# Fairhaven High School

## Town of Fairhaven ADA Transition Plan

January 2025

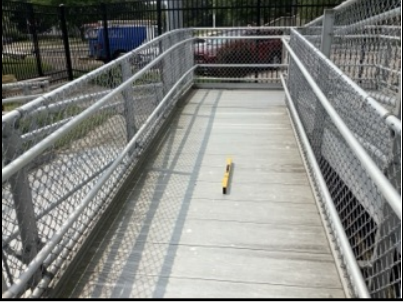
25	Curb Ramp on Southeast Corner of Building/ Across From Visitor Parking	Ext.	-	Curb Ramp	Blended Transition		Running slope is > 1:12 (8.33%)	10.8%	Reduce running slope to be no steeper than 1:12 (8.33%).	1	-	-

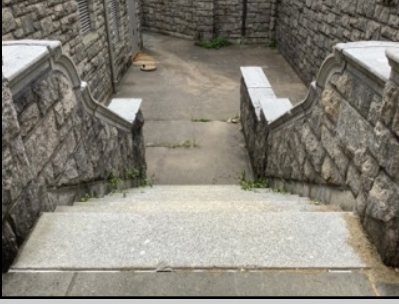
29	Accessible Parking by Northwest Corner of Library	Ext.	-	Off-Street Parking Lot or Garage	Visitor		Sign top > 96" above finished grade	120"	Locate sign with the top of the sign 96" max. above the ground measured to the top of the sign. Ensure that once the sign is repositioned, the base of the sign is at least 60" above the ground.	1	Labor	Labor
Exterior Ramp												
30	New Building, Ramp to South/Main Entrance	Ext.	-	Exterior Ramp	N/A		Running slope > 1:12 (8.33%) Handrails are not provided Handrails do not return properly	9.5% -	Reduce running slope to be no steeper than 1:12 (8.33%). Provide handrails with 1-1/4" to 1-1/2" circular cross sections. Ensure that handrail extensions return to a wall, guard, or the landing surface, or shall be continuous to the handrail of an adjacent ramp run.	1	-	-

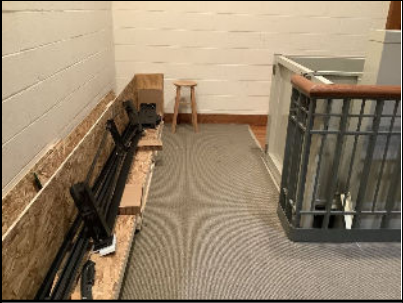
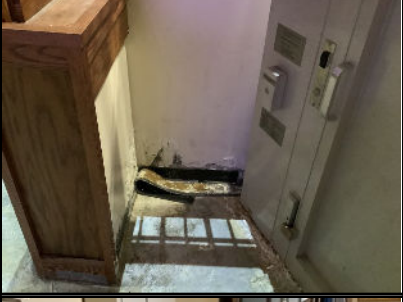
105	New Building, Ramp by North Entrance/ Near Auditorium	Ground Level	-	Ramps	Interior		Handrails do not extend 12" past top & bottom Handrails do not return properly	- -	Alter handrails to extend horizontally above the landing for 12" min. beyond the top and bottom of ramp runs. Once extensions are provided, ensure handrails return properly at the end of the ramp.	1	-	-

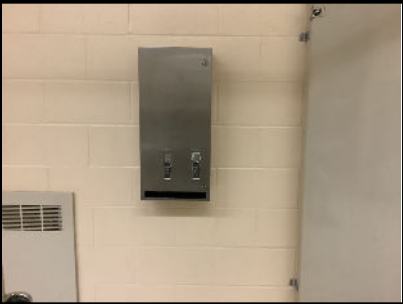
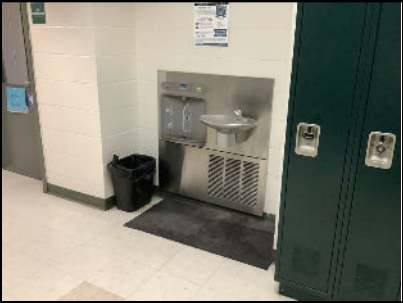
213	New Building, Women's Multi-User - Toilet Room Across From Room 201	2	-	Toilet Compartment	Accessible Compartment		Door has malfunctioning self-closing hinge Coat hook > 48" (2010 ADA) Door pull not provided	- 53" -	Repair hinge. Provide an additional coat hook no higher than 48" above the finished floor. Provide a door pull on each side of the door between 34" to 48" above the finished floor that does not require tight grasping, pinching or twisting of the wrist.	2	Labor 75 140	\$430
214	New Building, Women's Toilet Room Multi-User - Across From Main Office	1	-	Toilet Compartment	Accessible Compartment		Door has noncompliant hardware Door has malfunctioning self-closing hinge Door pull not provided	- - -	Provide hardware that can be operable with one hand and not require tight grasping, pinching, or twisting of the wrist. Repair hinge. Provide a door pull on each side of the door between 34" to 48" above the finished floor that does not require tight grasping, pinching or twisting of the wrist.	1	70 Labor 140	\$210
